GROWTH MANAGEMENT DEPARTMENT STAFF REPORT
VILANO BEACH TOWN CENTER OVERLAY DISTRICT
August 9, 2023 Public Meeting
VBTCDR 2023-02 The Vilano at Haley's Court

Summary of Request: Applicant is requesting design approval for improvements to the property located at 150 Vilano Road, known as Haley's Court. They are proposing changes in the building/accent colors, windows, doors, awnings, railings, and fencing.

Project Name The Vilano at Haley's Court

Windows

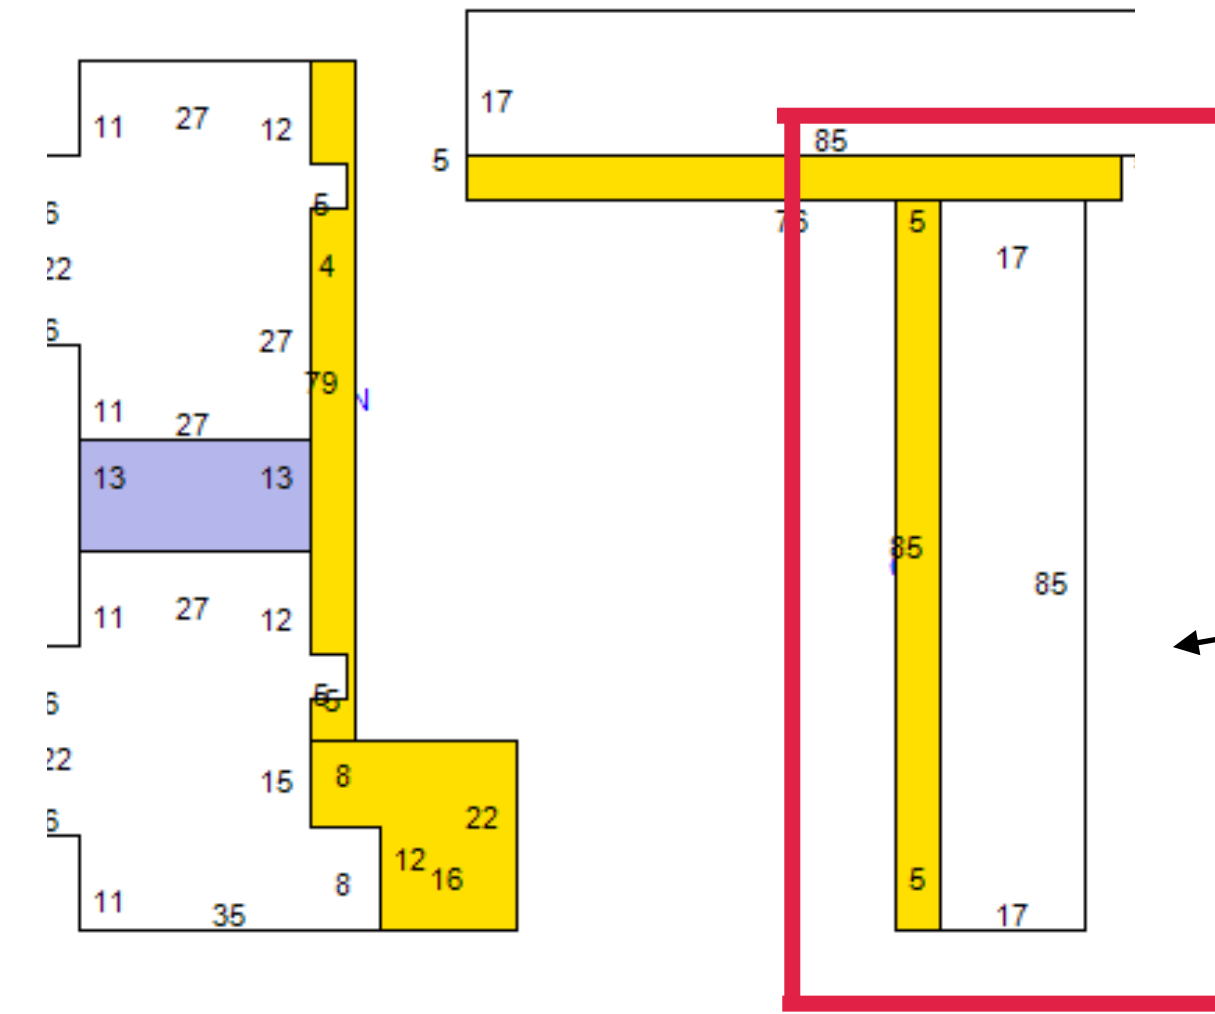
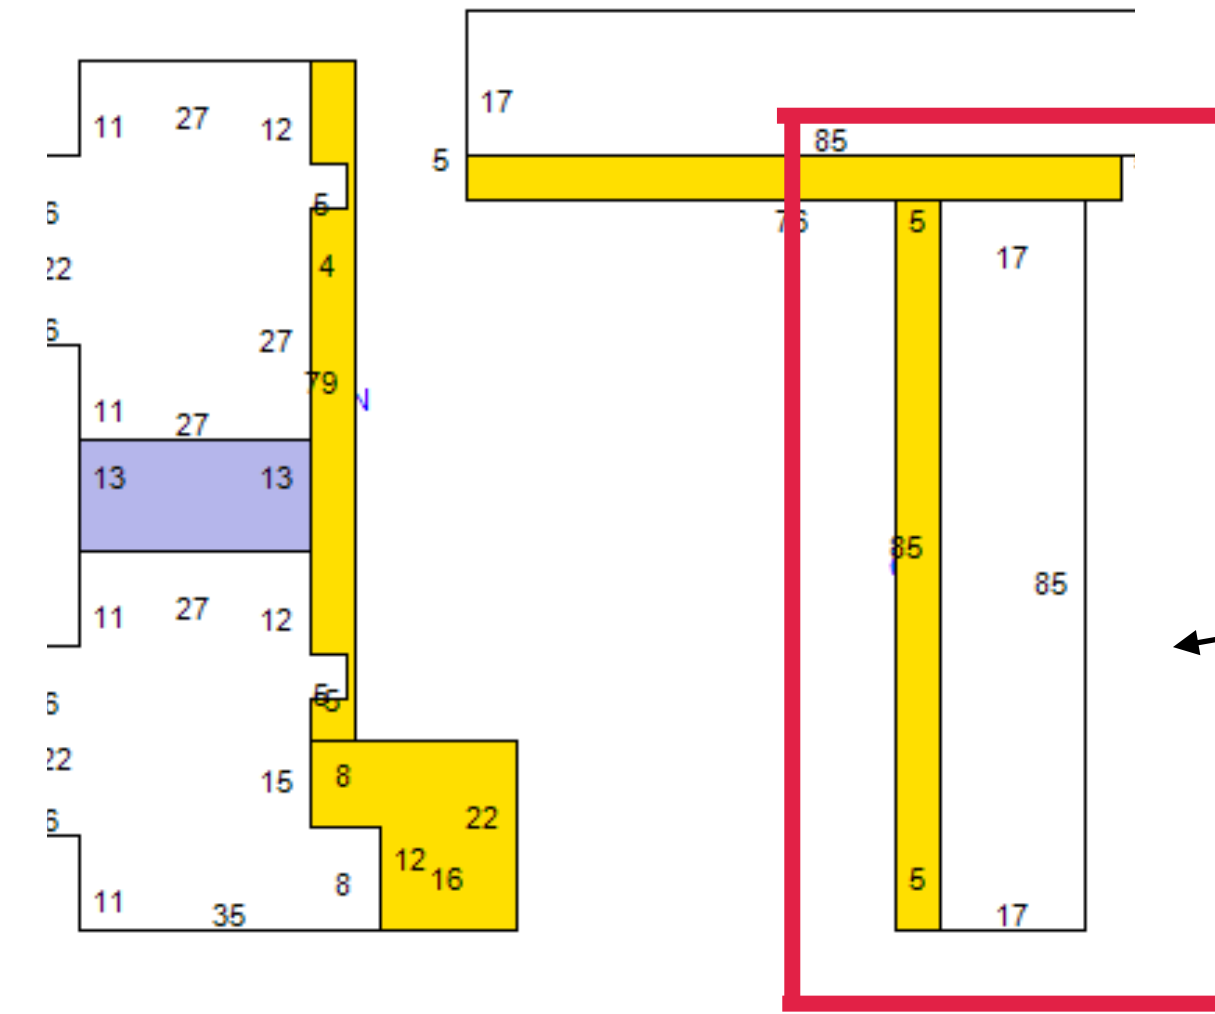
The white vinyl single hung impact glass windows appear to comply with the standards of Section 3.10. Staff is unsure if the proposed fixed windows that are being considered for the east side of the building comply. The DRB may ask the Applicant to clarify if those windows are fully operable as is required in LDC Section 3.10.05.G.16. Otherwise, it does appear the style of the windows fits with the Art Deco style of the building and surrounding area. *After speaking with Fire Services, the Applicant has informed Staff they are open to removing the fixed window option, to be in compliance with applicable LDC Section.*

16. All exterior doors, except garage doors, shall be hinged. All windows, except storefront windows shall be operable. *It appears that the proposed white vinyl single hung impact glass windows comply, but the fixed windows for the east side of the buildings on rooms with patios may not.*

EXTERIOR FENCE EAST SIDE OF BUILDING

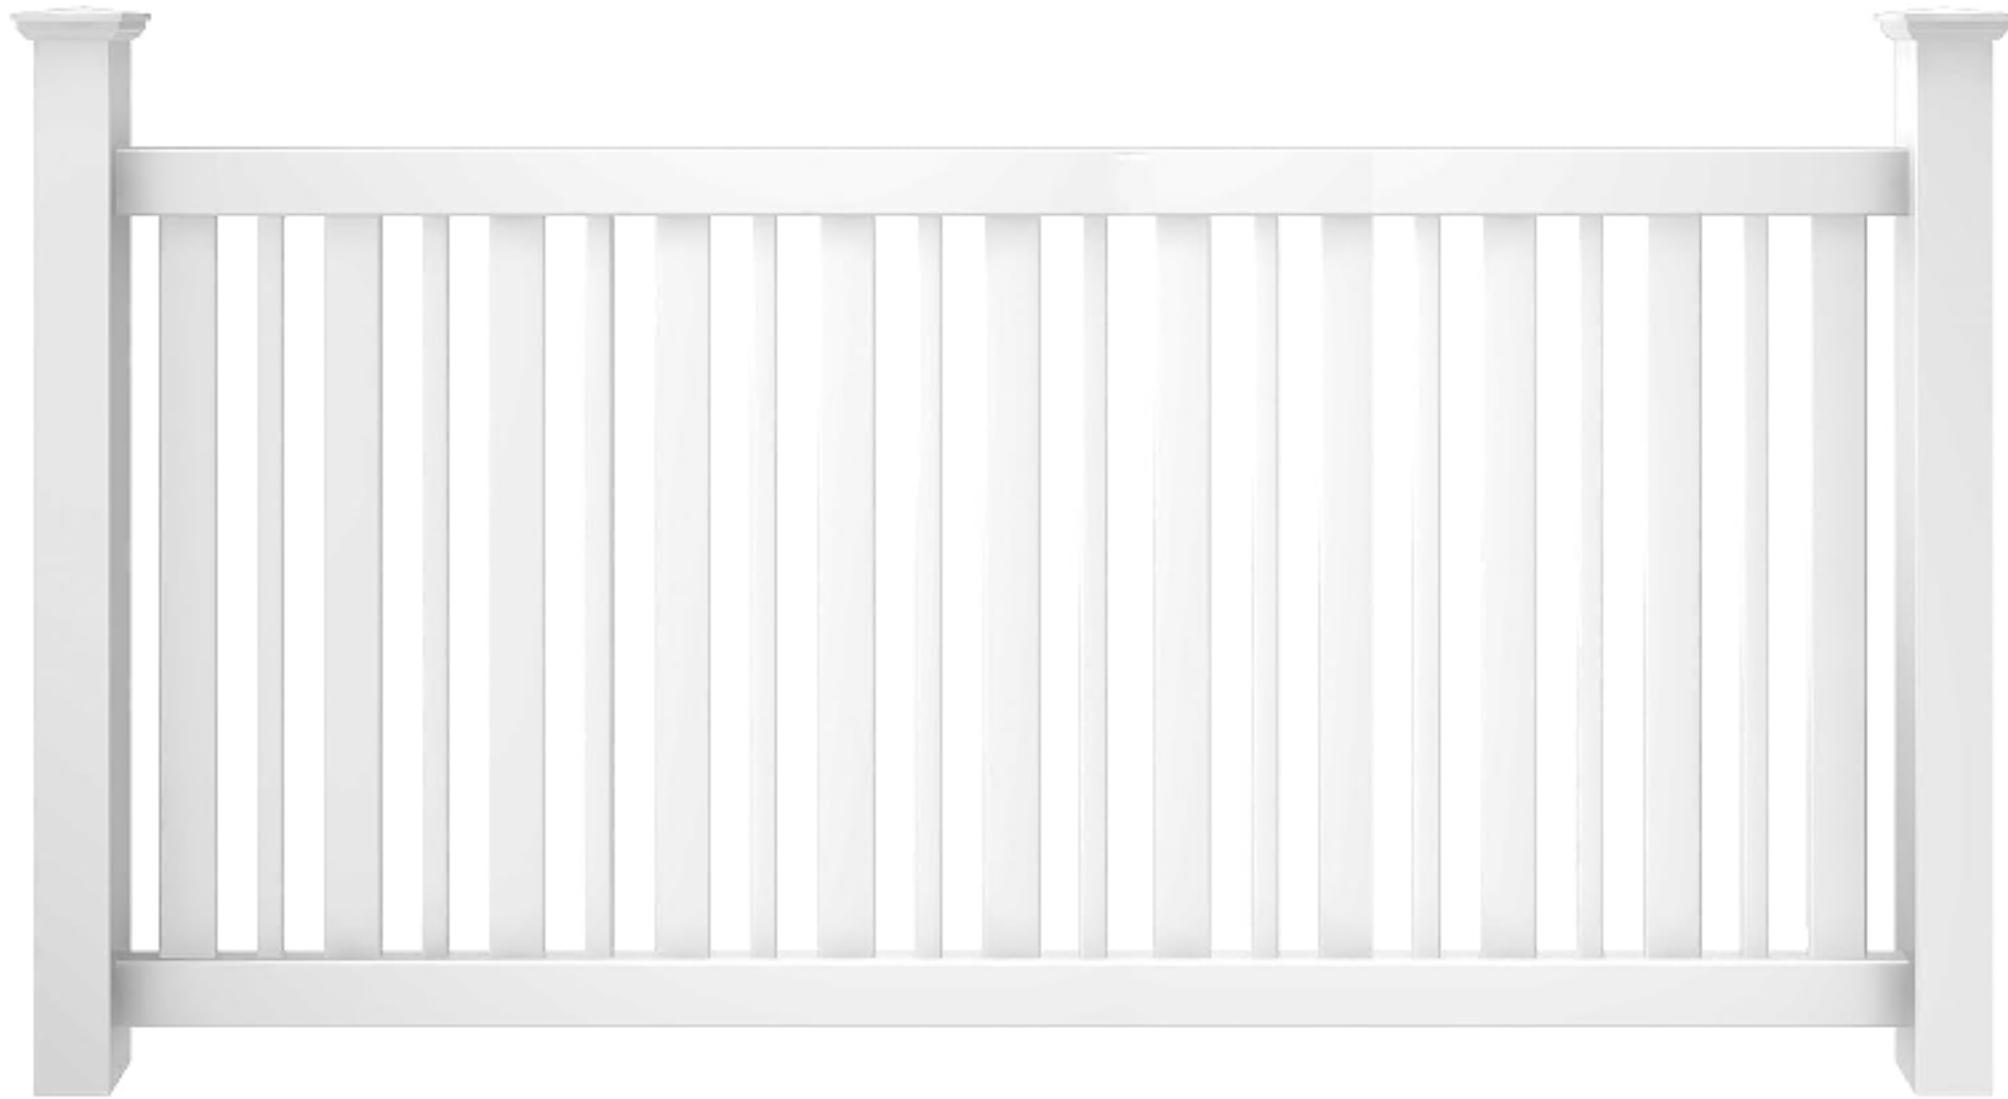
There does not appear to be specific design criteria for fences within LDC Section. The proposed fencing for the east side of the building would match the doors on that side of the building, the windows, as well as the beams and railings within the overhang areas of the site.

10. Chain link, barbed wire and similar fencing materials shall not be allowed within the District. *Proposed fencing complies with this standard.*

14. Balconies and or porches are intended as outdoor extensions of living space or commercial space for seating and shall not be utilized for storage. *Informational regarding proposed fenced-in living space extension on east side of building.*

Awning shape over back doors on east side.
The color will be black to match the current shingle roof.
Standard depth, width to cover the door only
Material: Metal

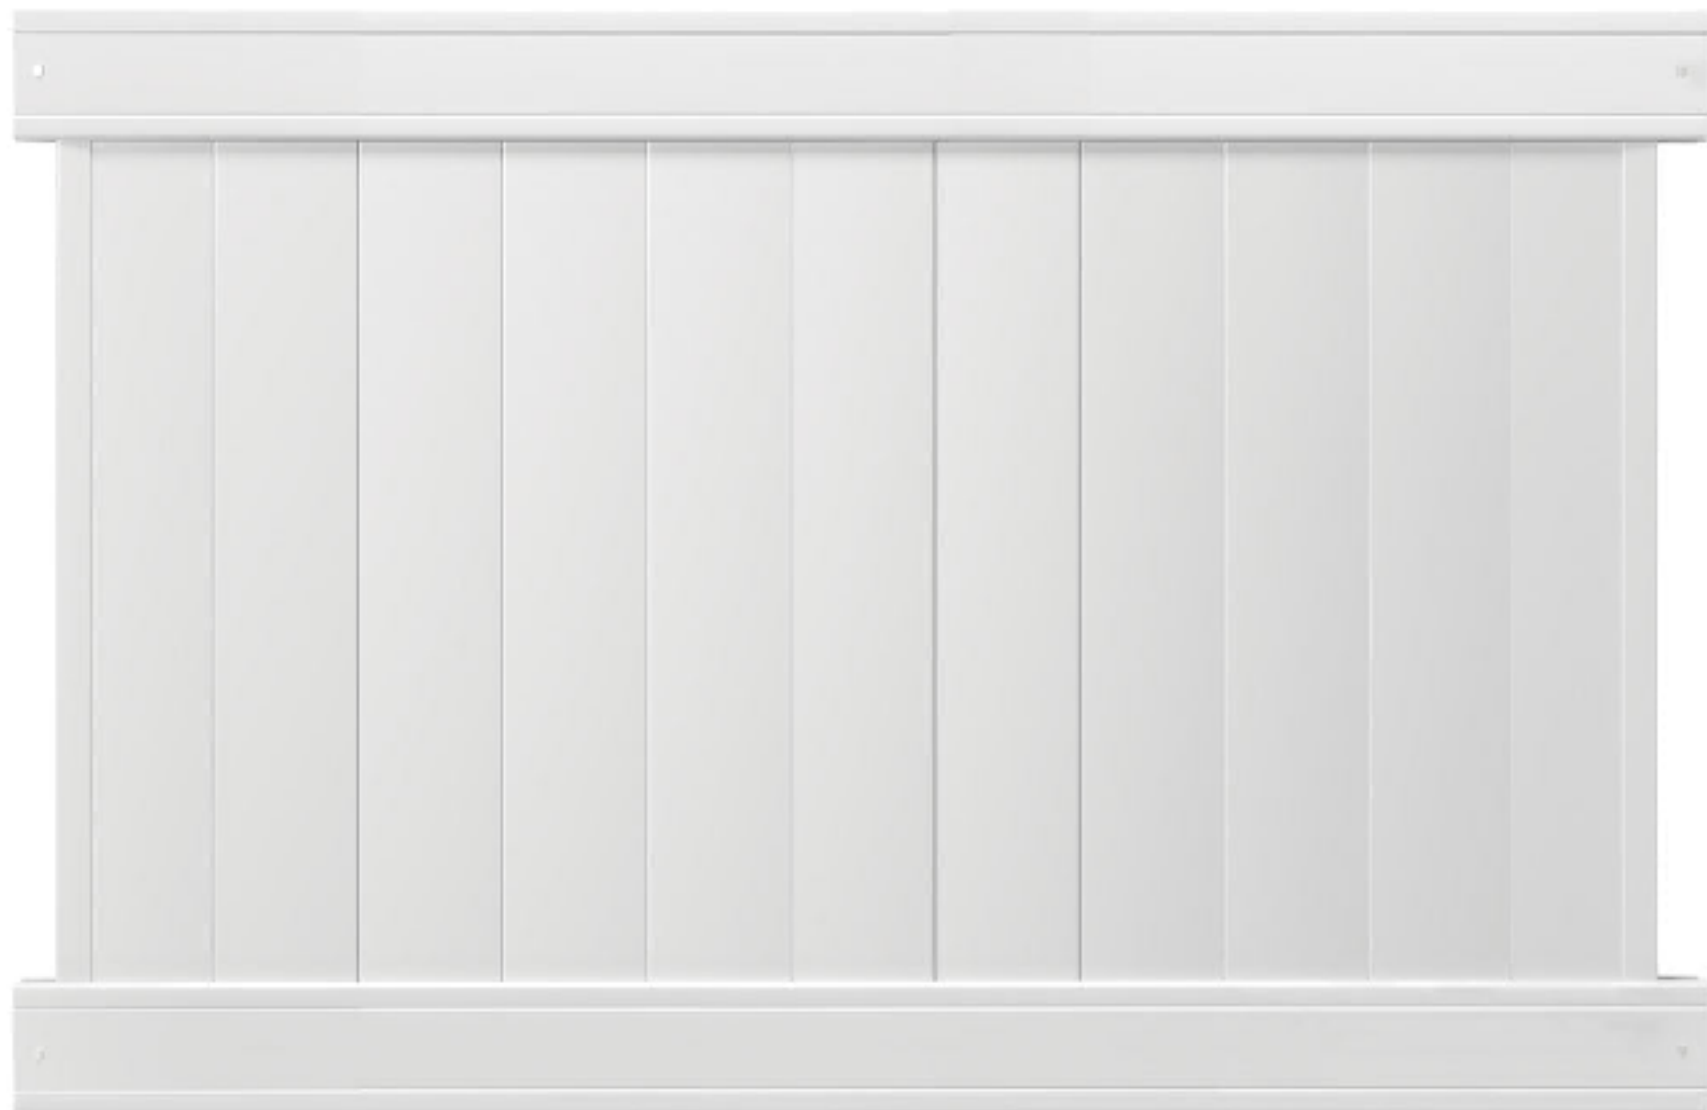
It appears the regulations applying to awnings for the Town Center are intended for cloth cover awnings that run across the entirety of a building façade. The DRB may prefer that the Applicant install cloth cover awnings over each door that better match the descriptions in LDC Sections 3.10.05.G.18 and 19 as are outlined below.

18. All awnings shall be sympathetic to the buildings architecture and designed as an integral component of the overall signage package. All awnings on the street level shall project a minimum of four (4) feet from the building façade. All awnings on stories above the first floor shall project a minimum of three (3) feet from the building façade. Variances may be granted administratively in the event that existing site features, such as, but not limited to, narrow sidewalks, utility line poles, and street trees restrict the applicant from full compliance with these regulations. All awnings shall be sloped 30 degrees from horizontal and shed awnings shall have both ends open. *Staff feels that the intent of this regulation is for awnings that run along a majority of the façade of the building for signage purposes and public use. In this case, the proposed "awnings" are limited to being above the private doors on the east side of the building facing the road. They appear to be for functional use of the doors, and not for signage purposes. Staff feels that this Code section does not fully apply to what is being proposed; the enforcement of this regulation would result in disproportion and not be cohesive with the character of the existing building.*

19. All awnings at street level shall have an eight (8) inch vertical valance along the front of the awning. The valance must be provided with concealed weight to prevent excessive movement in high winds. Internally illuminated or vinyl awnings are prohibited. *It appears the intention of this regulation is for awnings of a cloth material that project further than is proposed off of the building façade. Staff does not see this as necessary, however, a valance may be requested if that is preferred by the DRB for architectural purposes.*
